RECORD PLANS

STATE OF VERMONT
AGENCY OF TRANSPORTATION

RE-ERECTION OF HISTORIC BRIDGE NO. 18
OVER THE MISSISQUOI RIVER
TOWN OF SWANTON
COUNTY OF FRANKLIN

PLAN

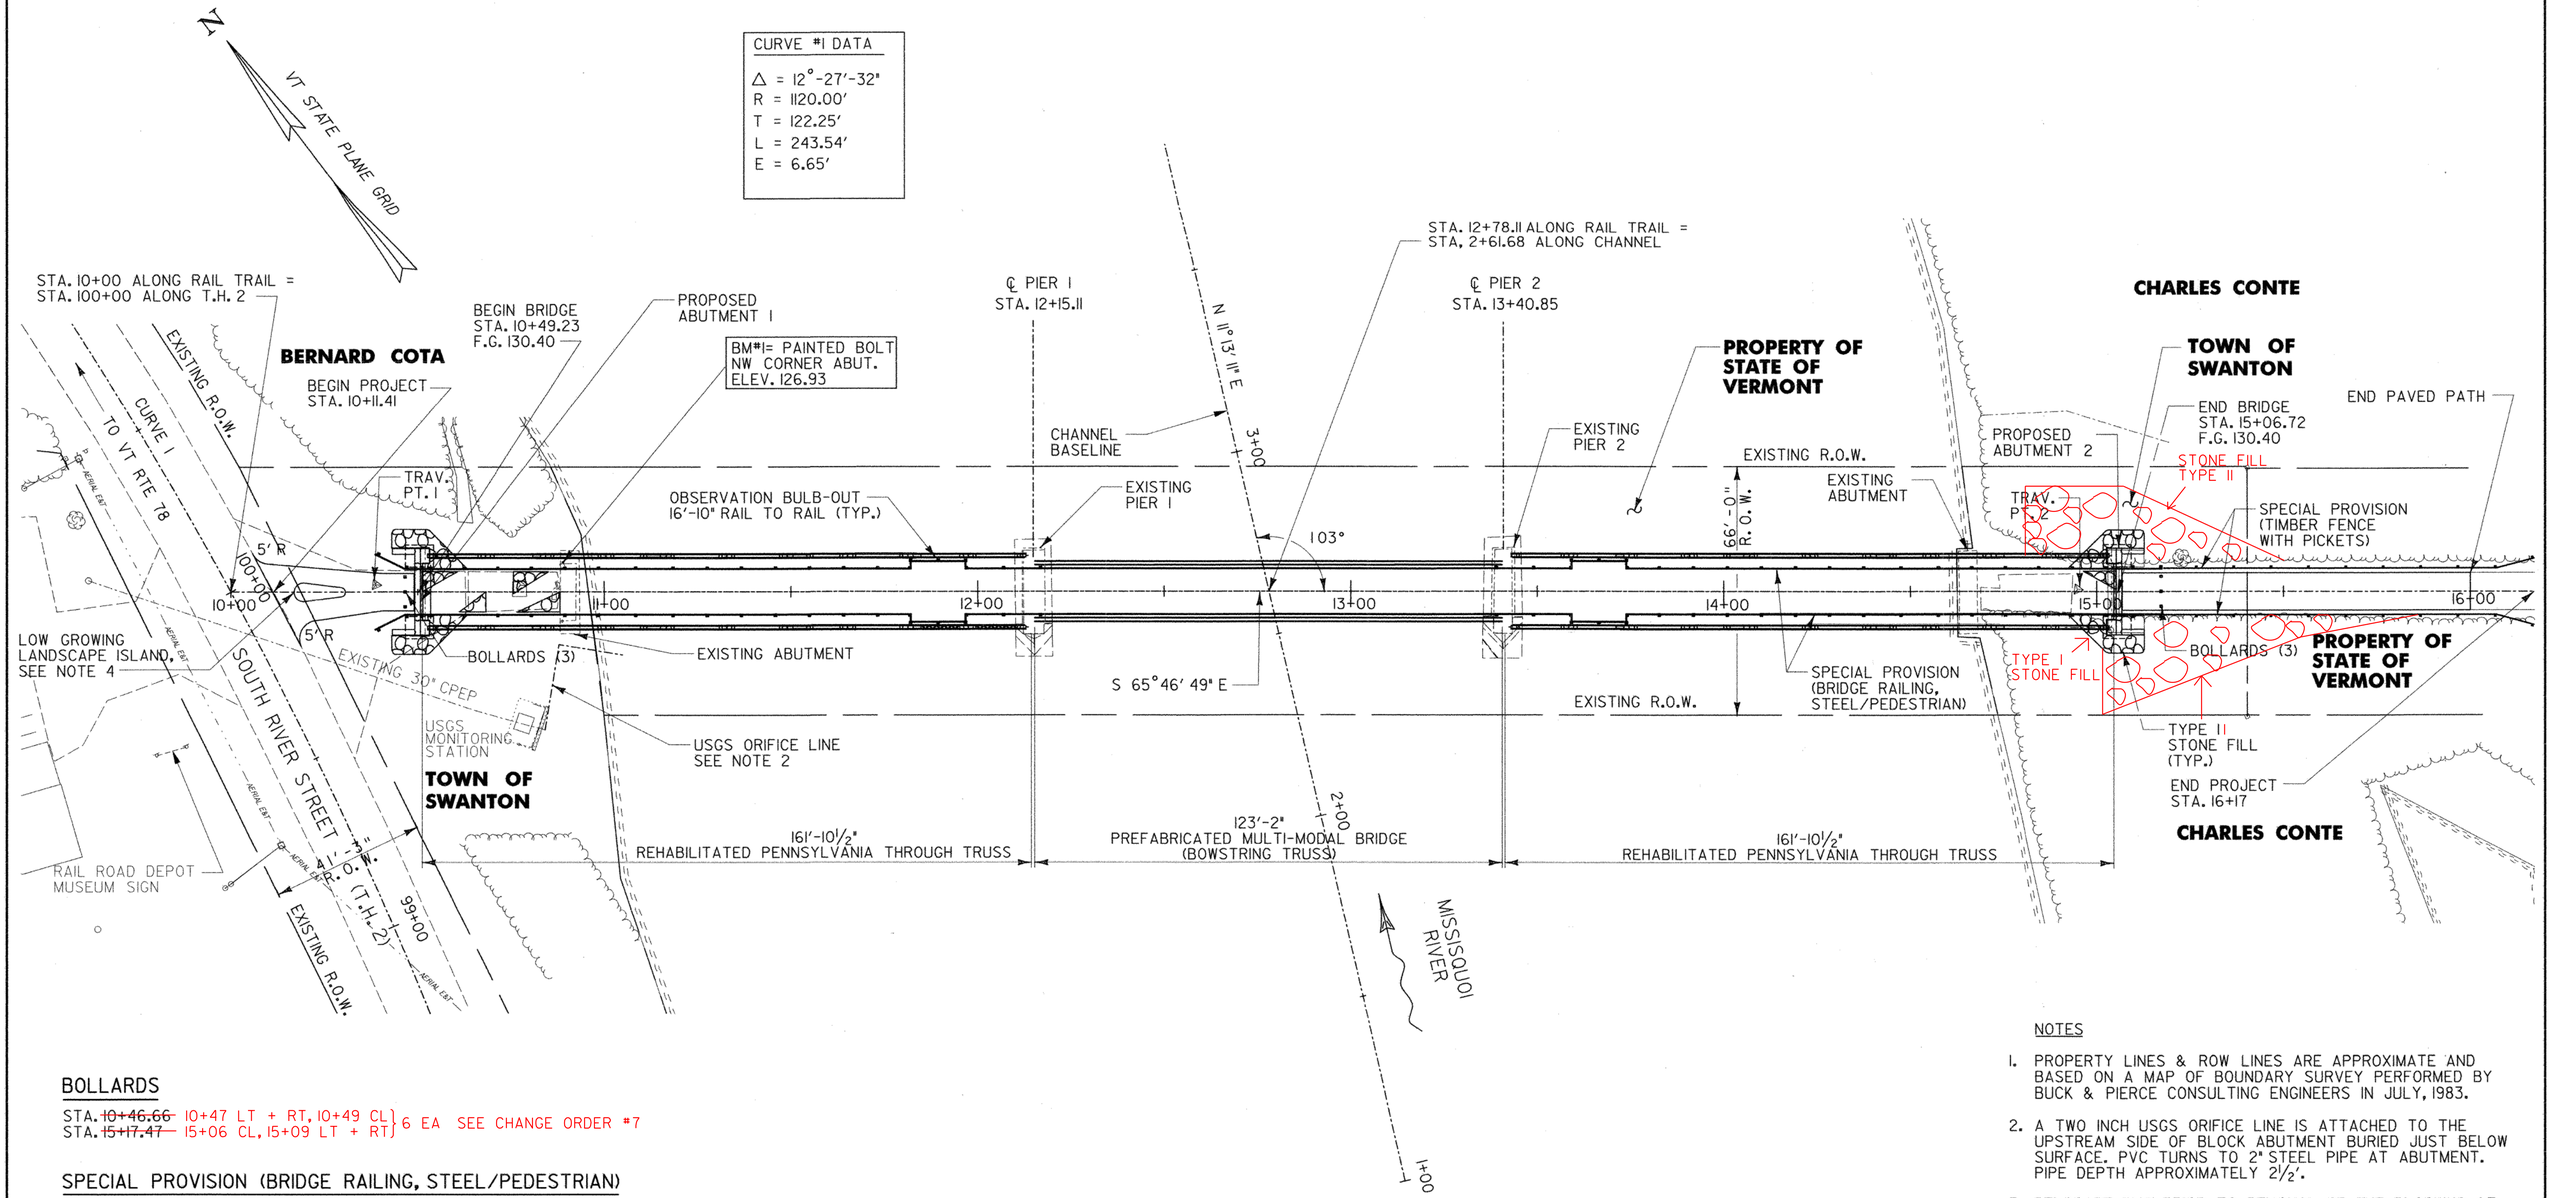
STA. ~~10+46.66~~ 10+47 LT + RT, 10+49 CL } 6 EA SEE CHANGE ORDER #7
STA. ~~15+17.47~~ 15+06 CL, 15+09 LT + RT }

REPAIR DETAIL

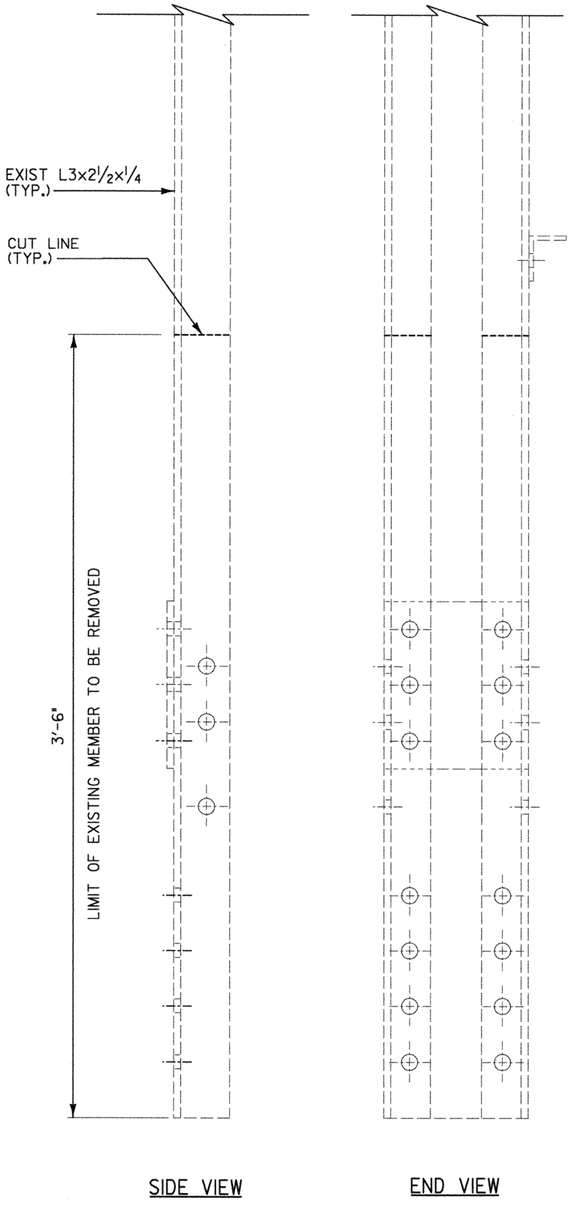
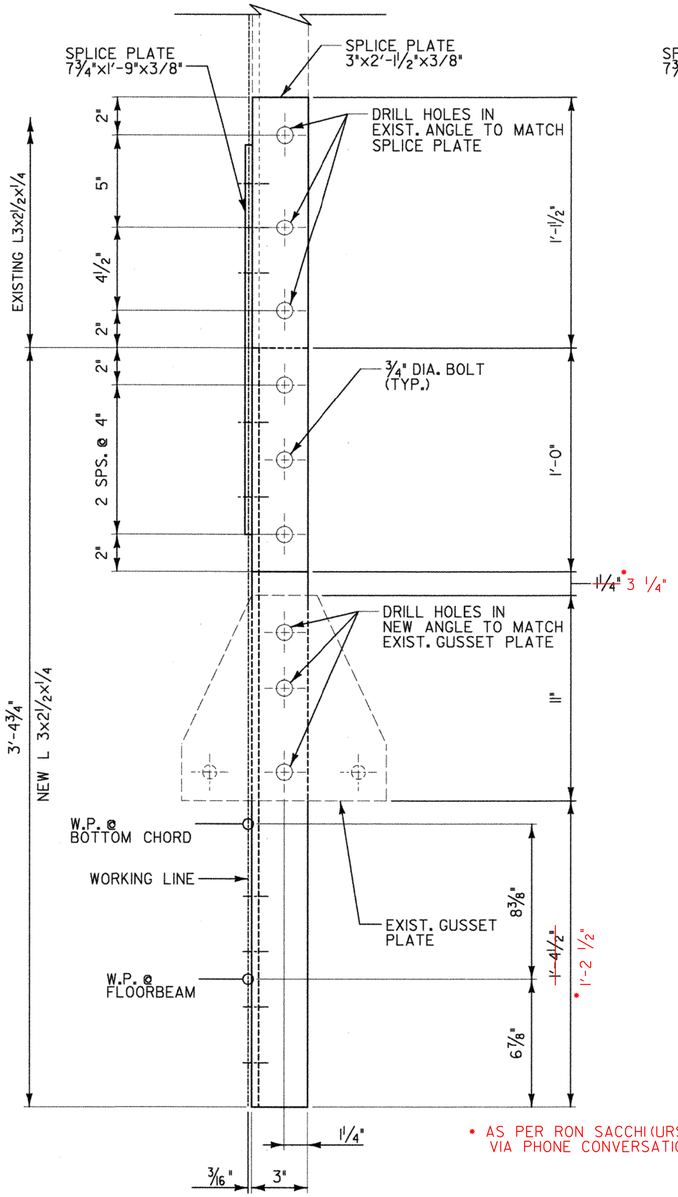
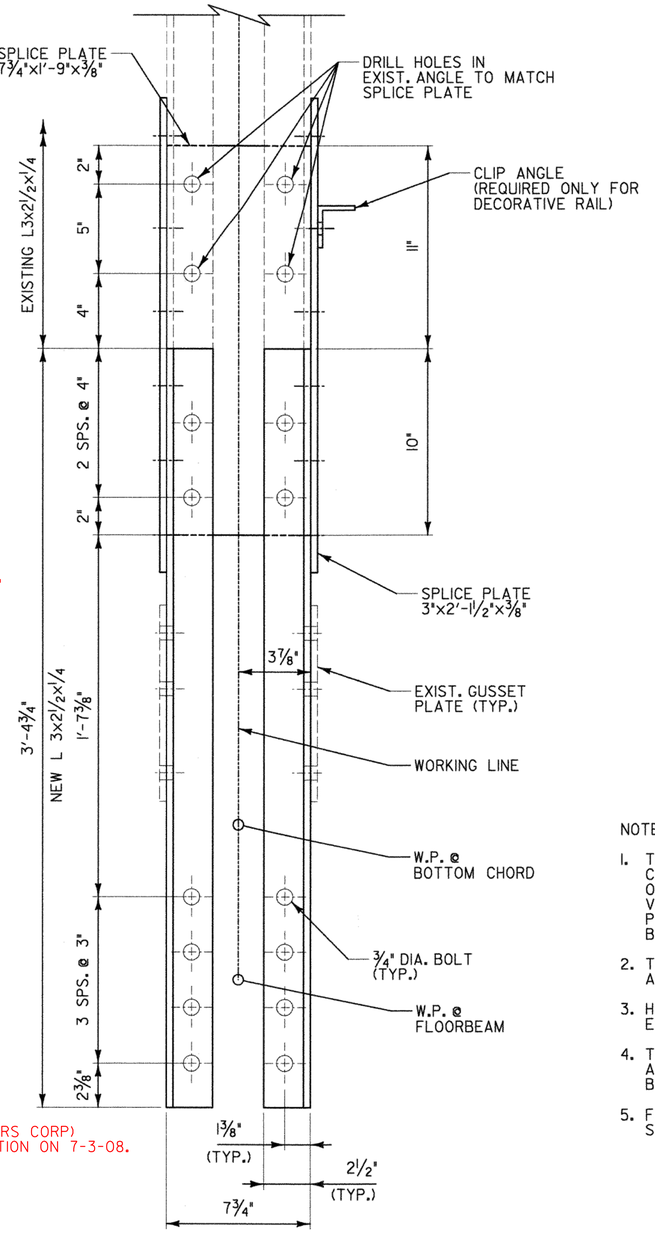
• AS PER RON SACCHI (URS CORP) VIA PHONE CONVERSATION ON 7-3-08.

PLAN
PIER 2 (PIER 1 SIMILAR DIMENSIONS)
SCALE: 3/8" = 1'-0"

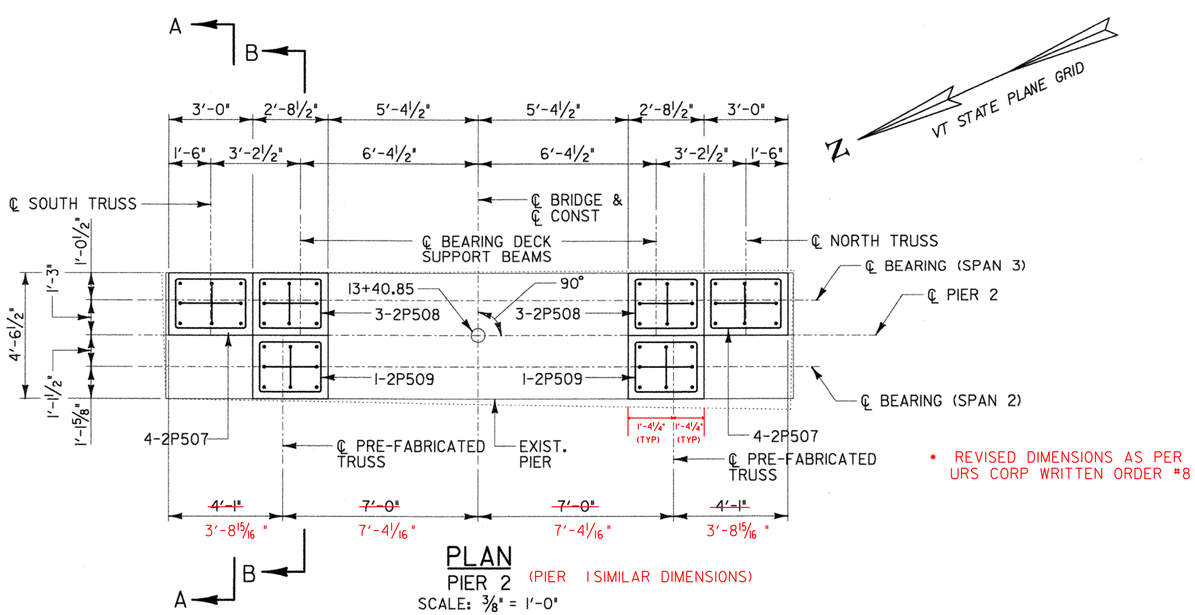
• REVISED DIMENSIONS AS PER URS CORP WRITTEN ORDER #8

TRUSS BRIDGE SECTION VIEWS

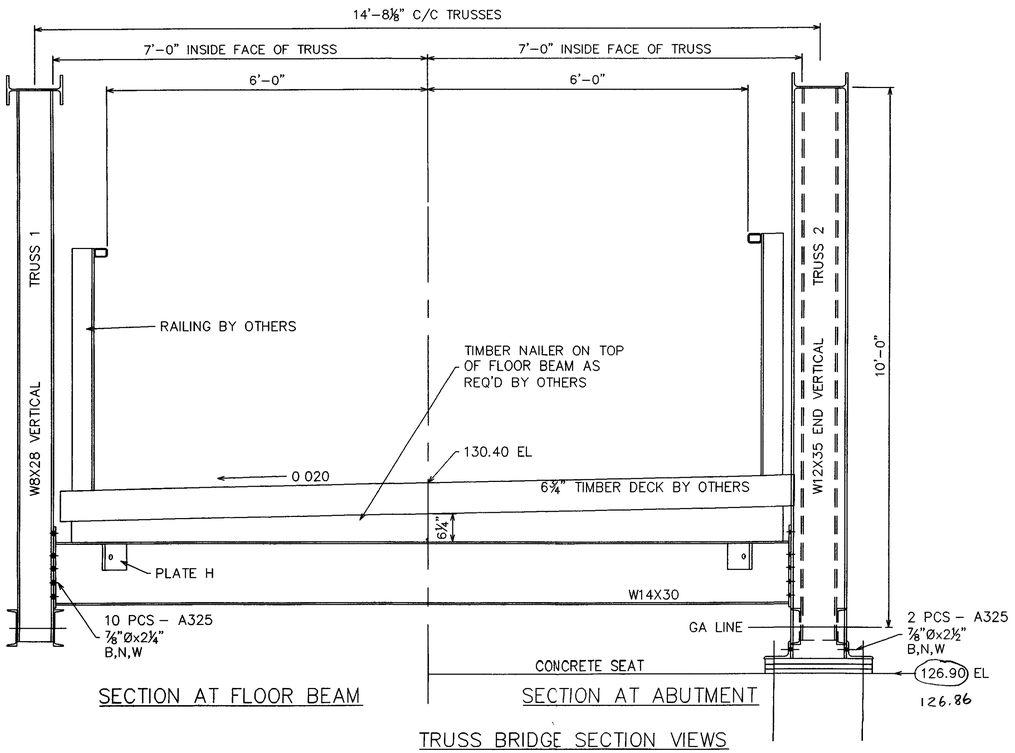
* PER LAST SUBMITTAL, AASHTO ROTATION CRITERIA WAS CITED, BUT TO COMPLY WITH VAOT STRUCTURE MANUAL, SECTION 2315 AND FIGURE 23-3, PLEASE INCREASE BEARING THICKNESS TO 1"2".
